Bognor Regis Golf Club

Outline Planning application for the Construction of up to 480 new homes (C3), the formation of a new means of access onto Golf Links Road, the creation of new surface water drainage, new landscaping and habitat creation, ground works and other infrastructure. The retention and re-purposing of the retained club house (F2) – LPA Reference: FP/274/21/OUT
Hallam Land Management Limited

TECHNICAL NOTE

DATE:	06 October 2022	CONFIDENTIALITY:	Public
SUBJECT:	WSP Response to EA Comments		
PROJECT:	Bognor Golf Course Hydraulic Model	AUTHOR:	Andy Smith

Annex 1 – Movement and Connectivity Parameter Plan (drawing number: 171-UW-P-A-009-Rev E)

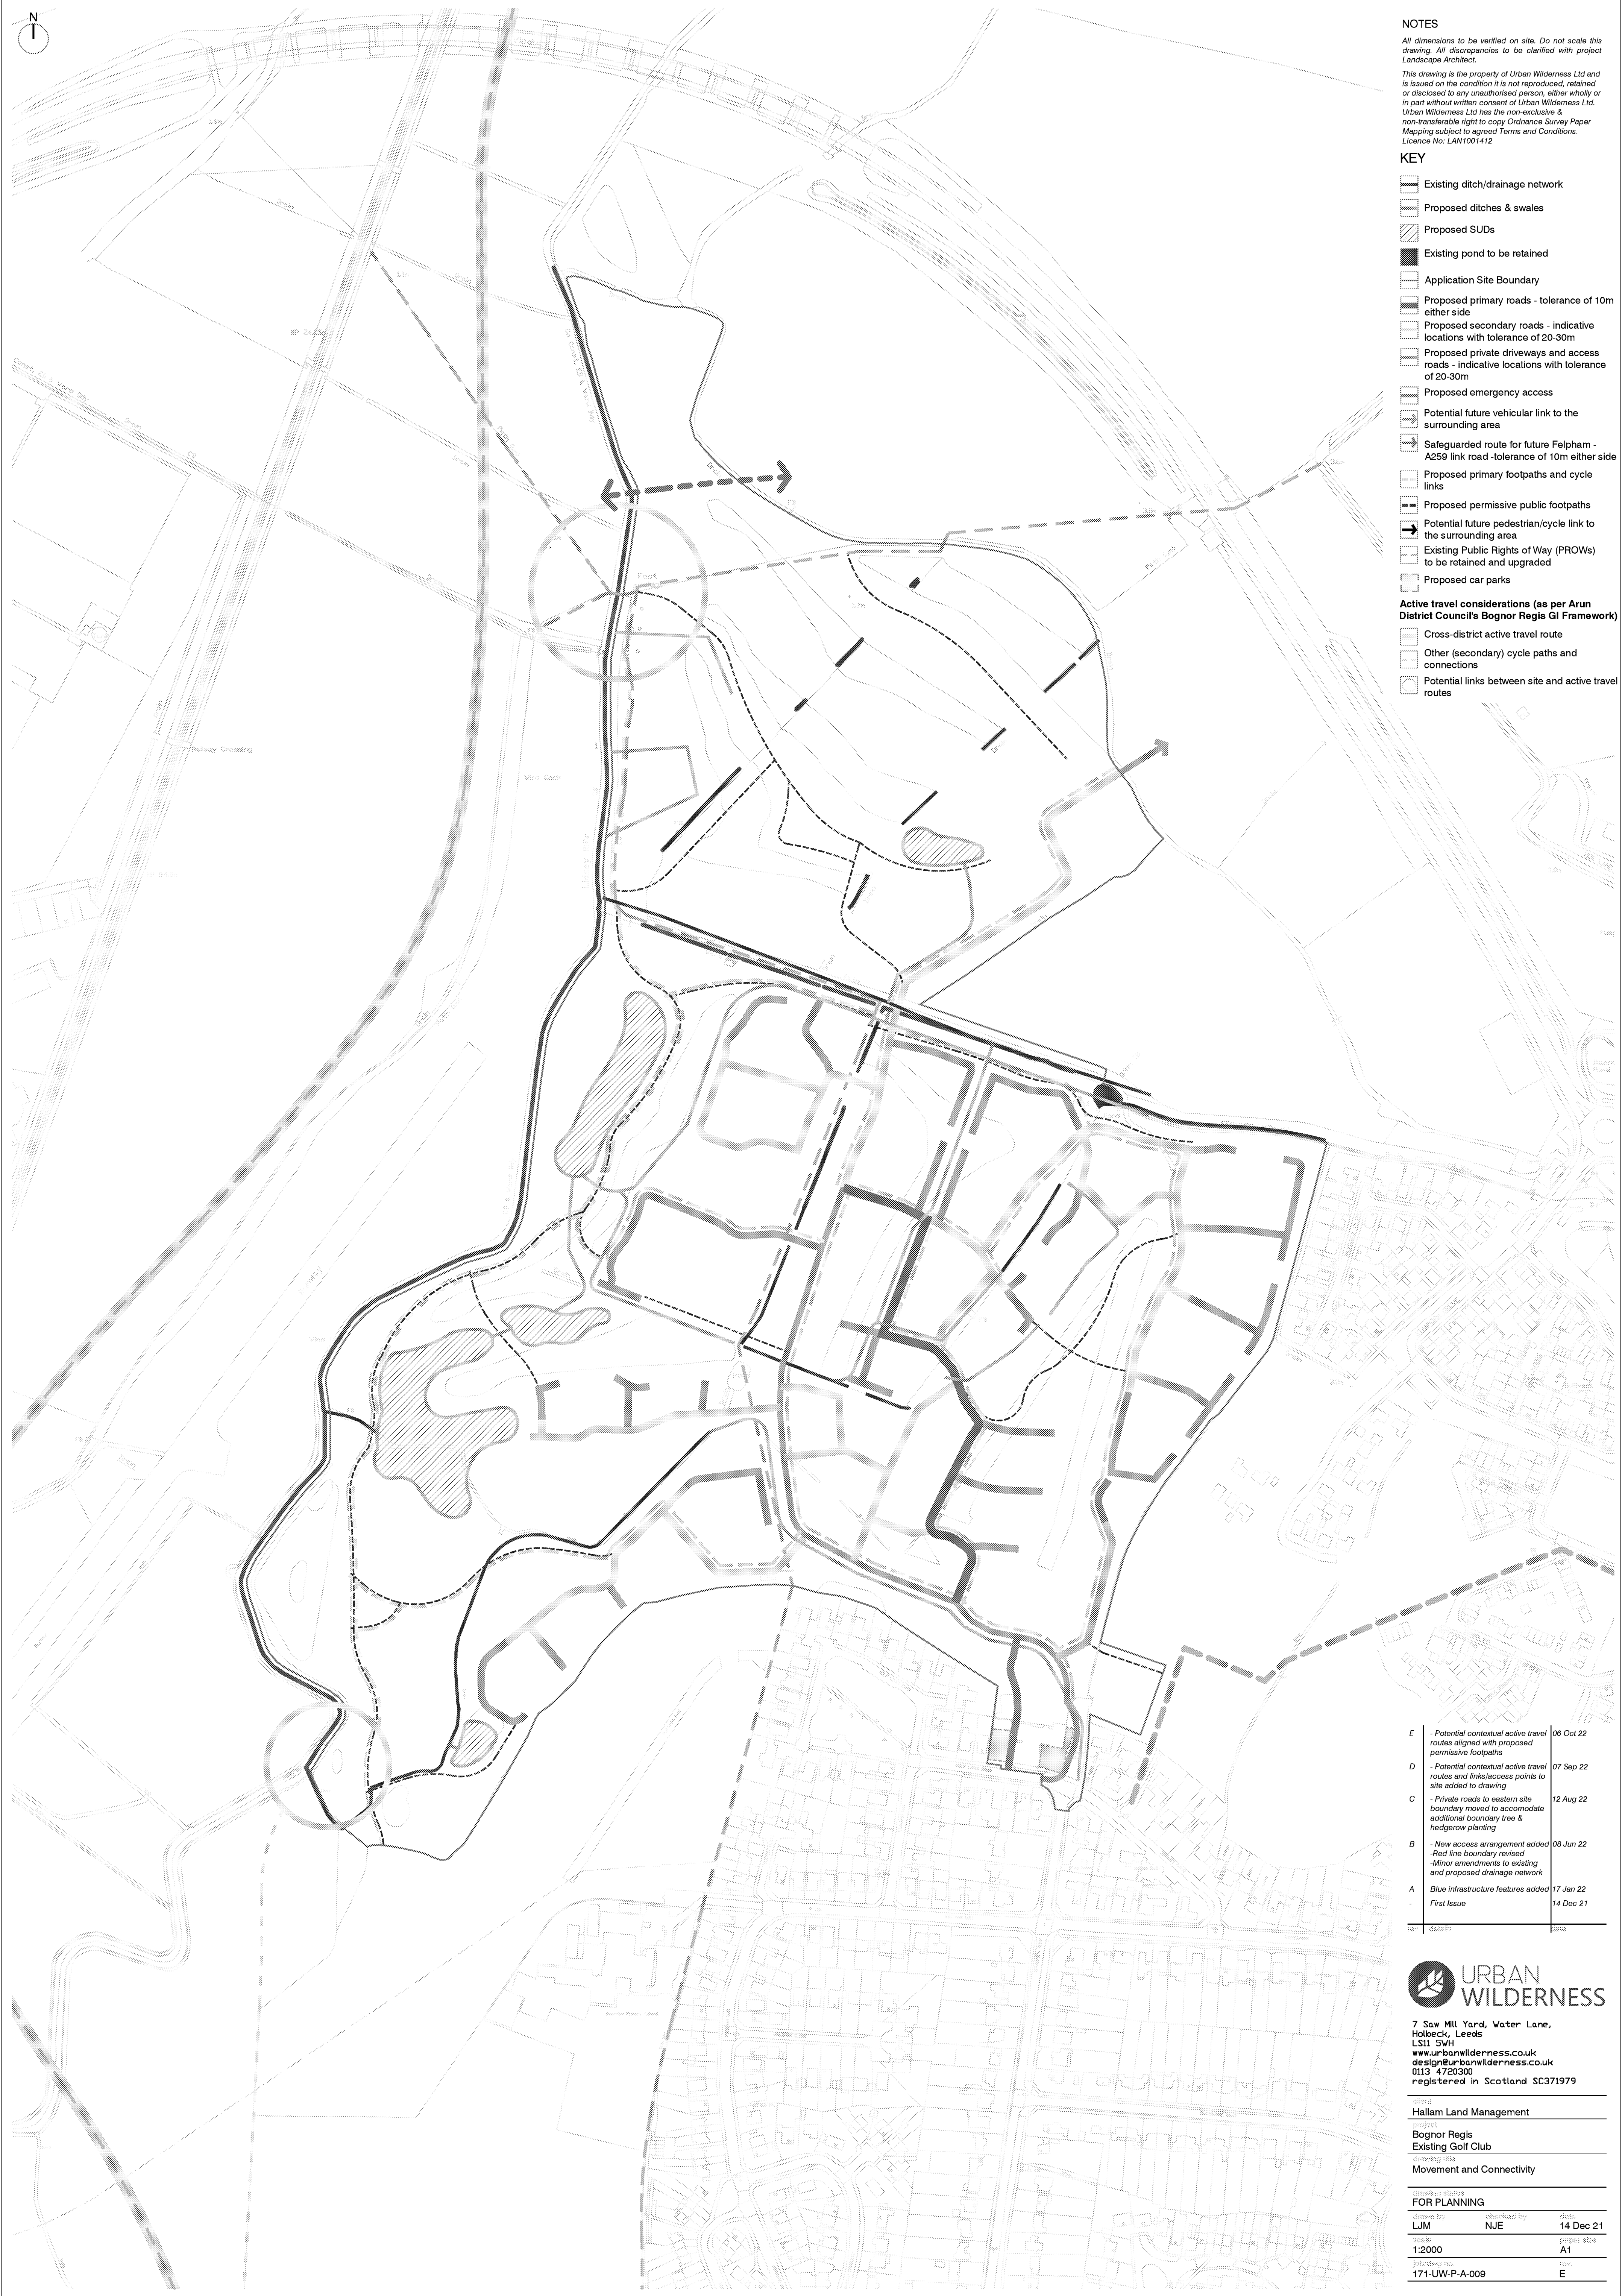
As raised in the meeting on the 24th August the Council would like to understand whether the Applicant has considered the potential to form a connection with the cross District active travel corridor shown on the Landscape & Green Infrastructure Framework connecting Bognor Regis to the South Downs National Park as set out in the Bognor Regis Green Infrastructure Framework (January 2020).

HLM's urban designer, Urban Wilderness, has indicated on the accompanying Movement and Connectivity Parameter Plan (Rev E), which is provided for illustrative purposes at Annex 1, how the scheme has the potential to connect to this route, which is to the west of the Rife and outside the application site. The proposed footpaths and cycle paths within the proposal have the potential to link to the proposed route. This plan is not intended for formal submission, it is however for your use to understand the capability of the scheme to connect to this route.

Flexible Report Produced by Admin (06/09/2022 17:05:30) Page 1 of 1
Rainfall event: >WSP 2022 - For EA>Hydrology>100 year 10.25 hr mm/hr + 25%CC (19/11/2021 16:05:03)

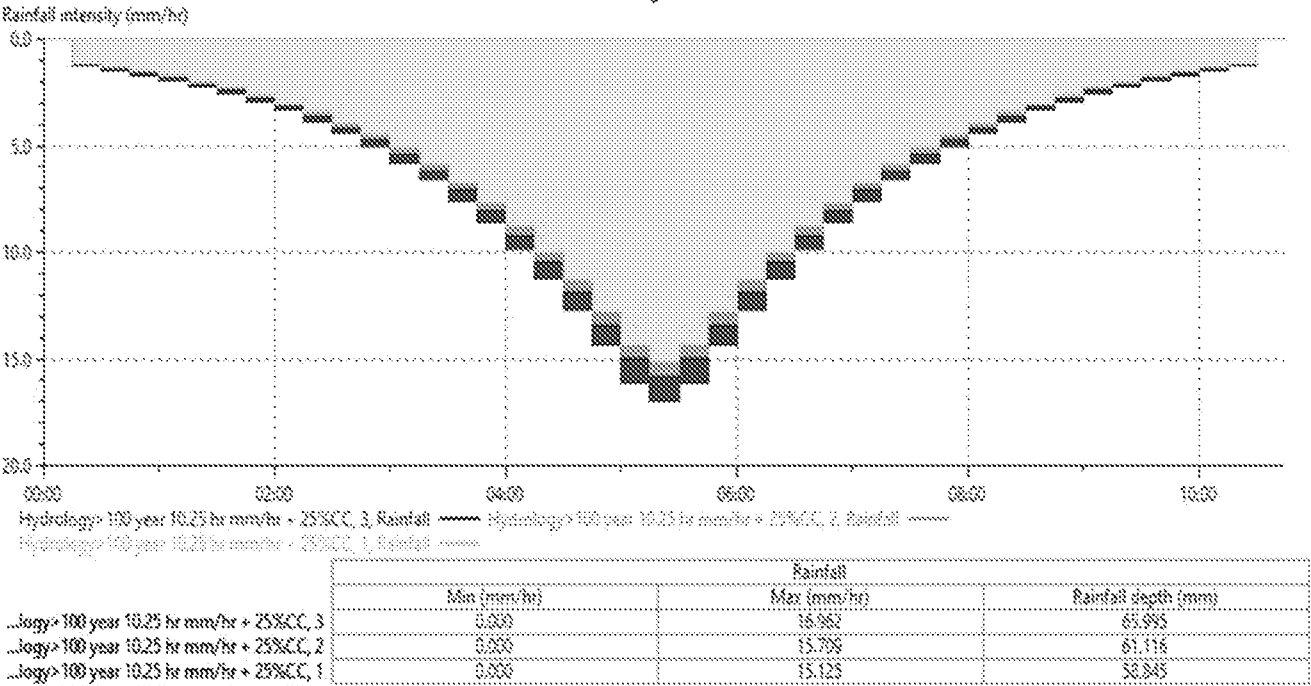
- 2. An example rainfall hyetograph has been included in the hydrology report (figure 4). In addition, a table is presented in table 4 which presents the revised rainfall depths. The rainfall hyetographs and depths presented in the hydrology report were compared against the rainfall data for the 100 year 10.25 hr mm/hr+25%CC scenario included within the Infoworks Model. There appear to be differences between the rainfall applied within the hydraulic model and the rainfall rate/depths reported within the hydrology report. Please clarify why there are differences.*

There are no differences between the rainfall within the hydraulic model and the rainfall reported within the hydrology report. The difference observed by the reviewer was caused by the data within the report being the current day scenario (i.e. no climate change allowance) and that within the model being for the future scenario (i.e. with climate change) for ease of approval the table has been updated below and the extract from the model provided by the Environment Agency reviewer is also below, noting that in the image the rainfall depths are presented in the reverse order than those in the table.
